Mr. John F. Stolz, Chief
Light Water Reactors Branch No. 1
Division of Project Management
U. S. Nuclear Regulatory Commission
Washington, D. C. 20555Re: Docket No. 50-275-OL
Docket No. 50-323-OL
Diablo Canyon Units 1 & 2

Enclosed in support of our operating license application are responses to informal questions 1 through 10 transmitted to PG&E in an August 4, 1978 memorandum on the subject of seismic qualifications.

This package contains non-proprietary responses to informal questions 1 through 10 transmitted to PGandE in an August 4, 1978 memorandum on the subject of Seismic Qualifications.

FIGURE 4 (cont'd)

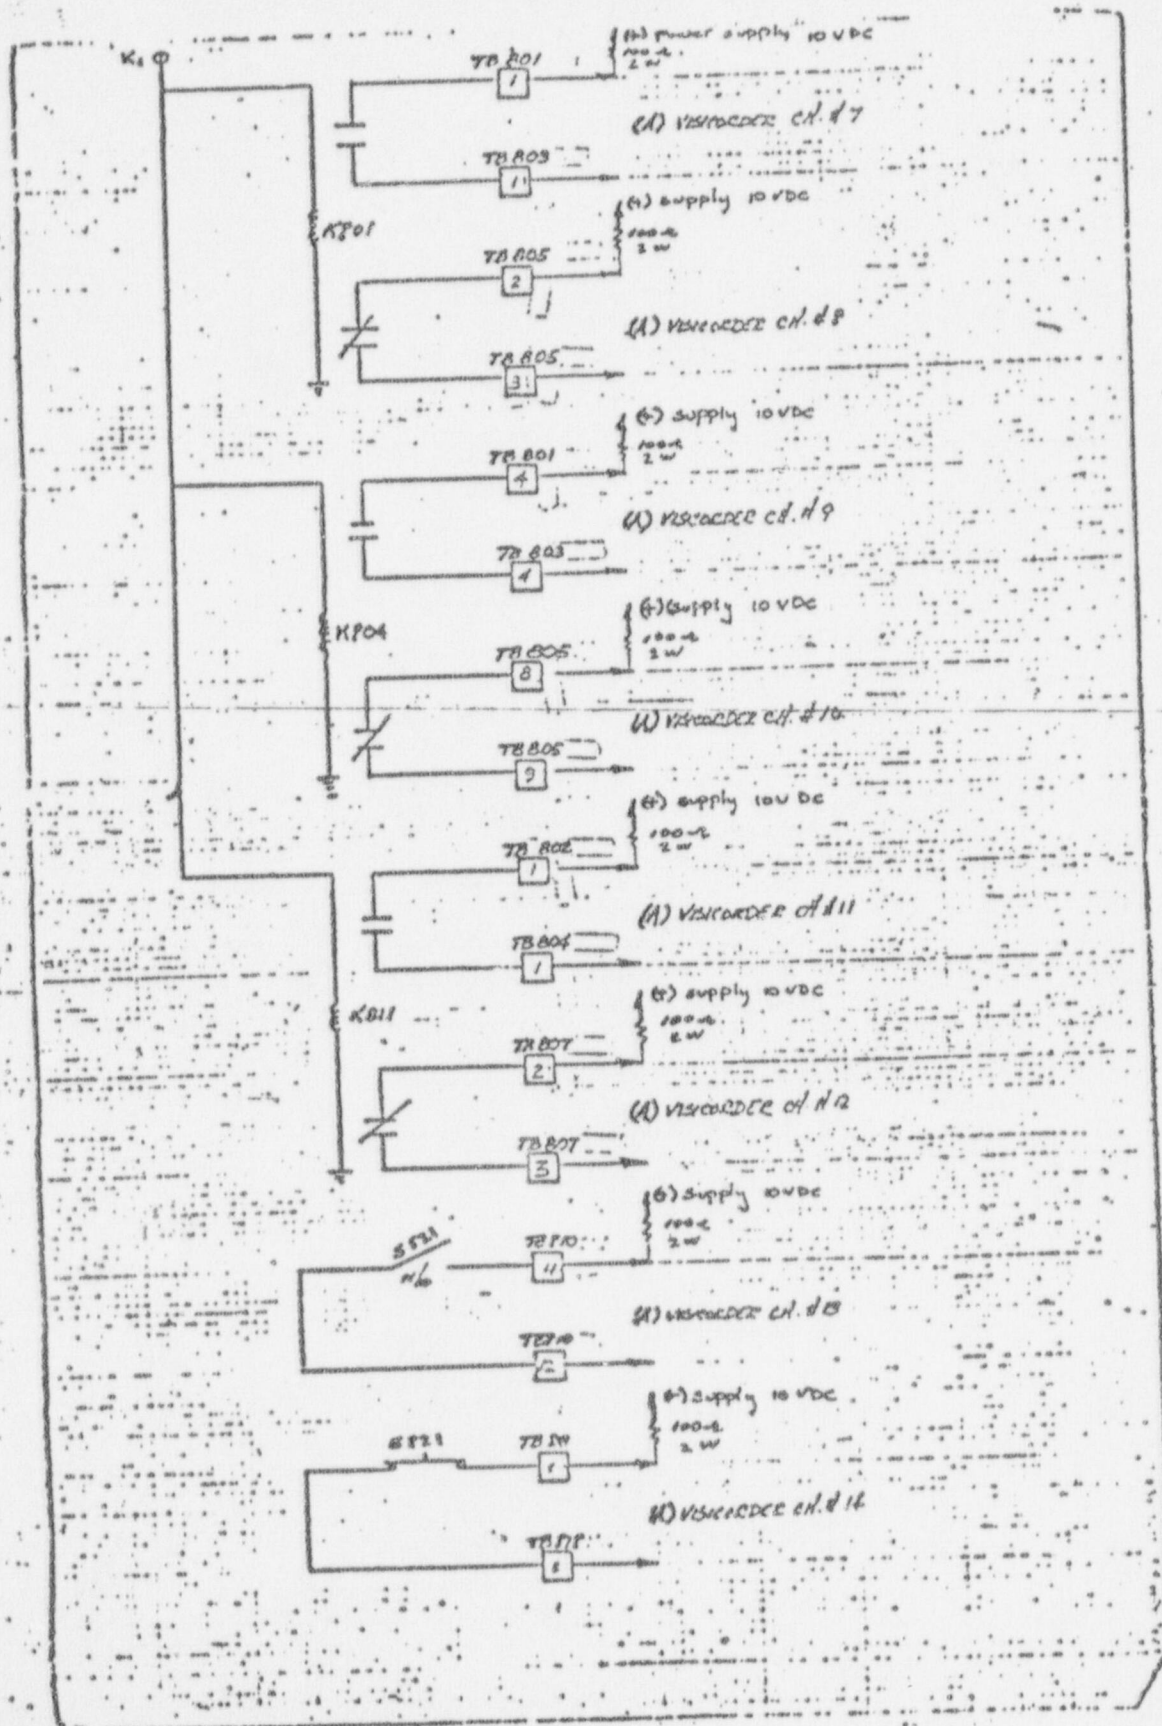
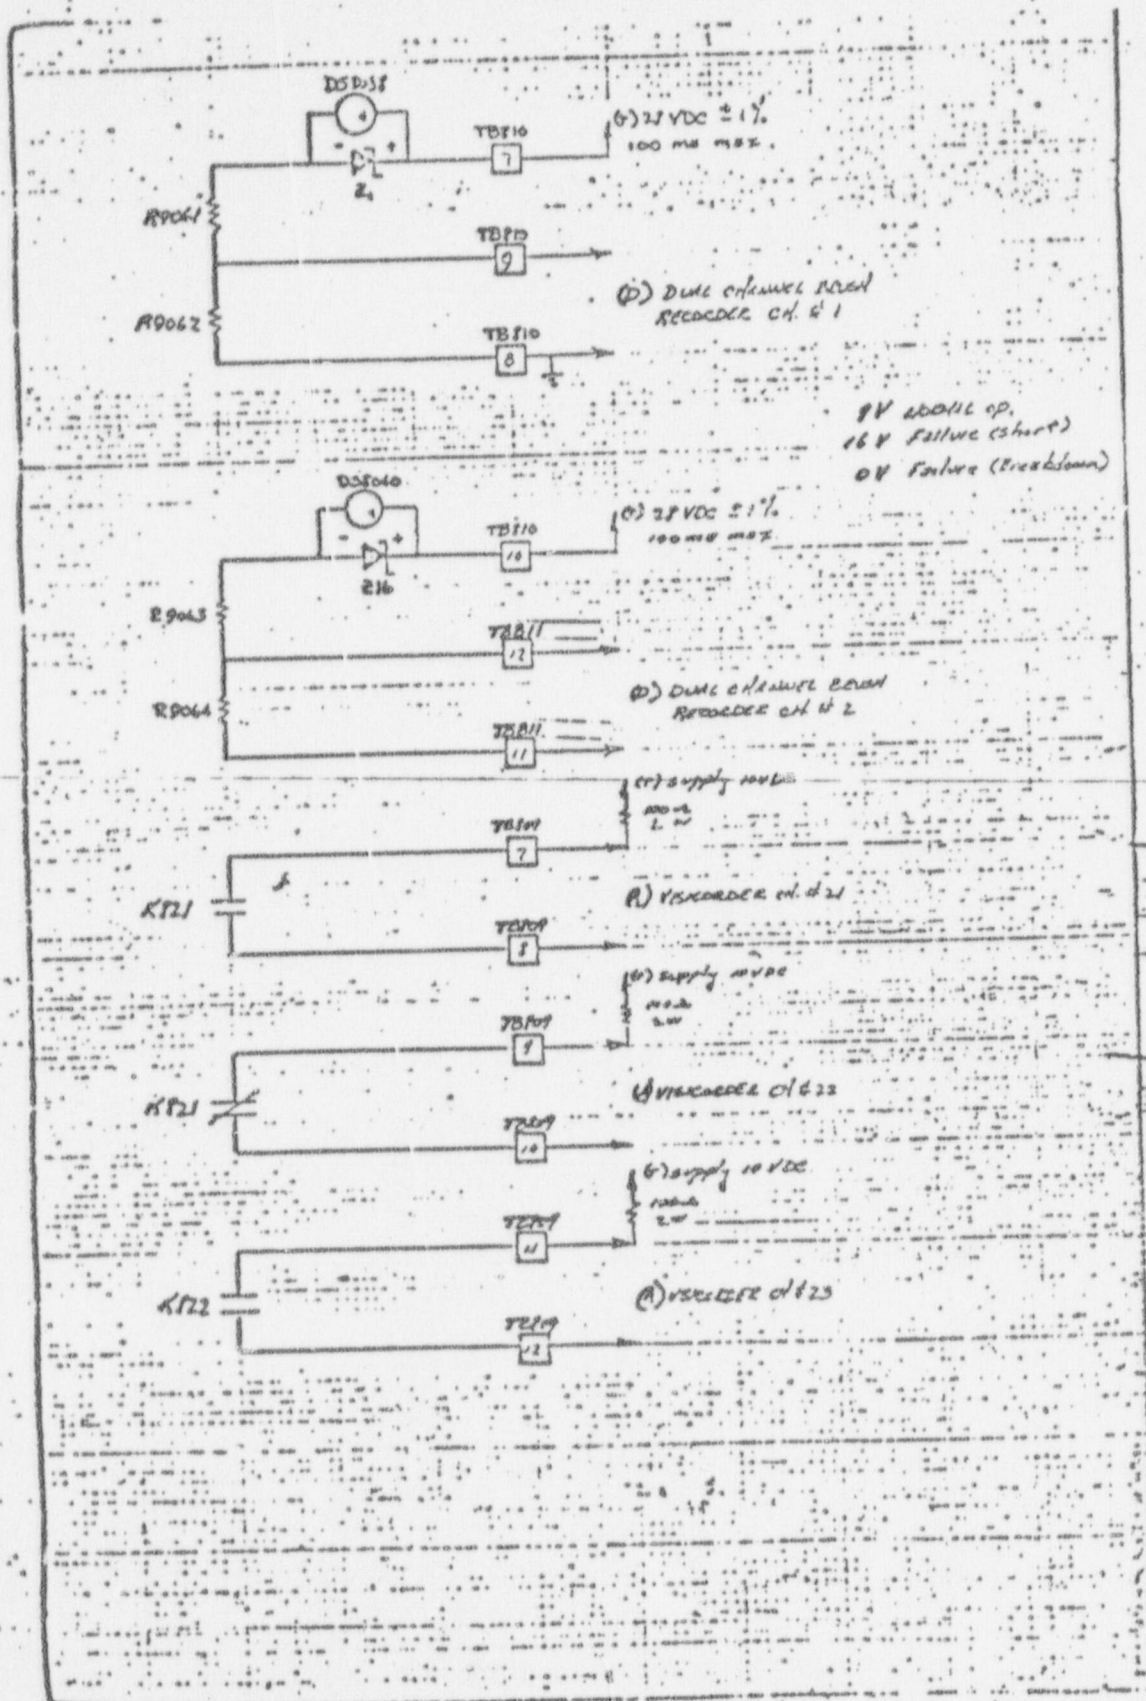
Provide electrical schematic diagrams of the test cabinet circuitry, describe the test set up, and identify the selected relays, switches, and components monitored during testing. Justify the seismic adequacy of relays, switches, and components that were not monitored during seismic testing.

Figure 4 shows the electrical test setup for monitoring selected switches, relays, and resistor-light-diode combinations of the Safeguards Test Cabinet during its seismic test. You will note that normally open and normally closed contacts of switches S804, S807, S818 and S821 were monitored, as were normally open and normally closed contacts of relays K801, K804, K811, K821 and K822. Two light-diode combinations, DS8038 and DS8040 were also monitored for continuity. Component location is shown in Figure 5.

Switches located in the top row (middle and side) and 3rd row (middle) were monitored. Relays located in the top row (side and middle), 2nd row (middle) and bottom row (side) were monitored.
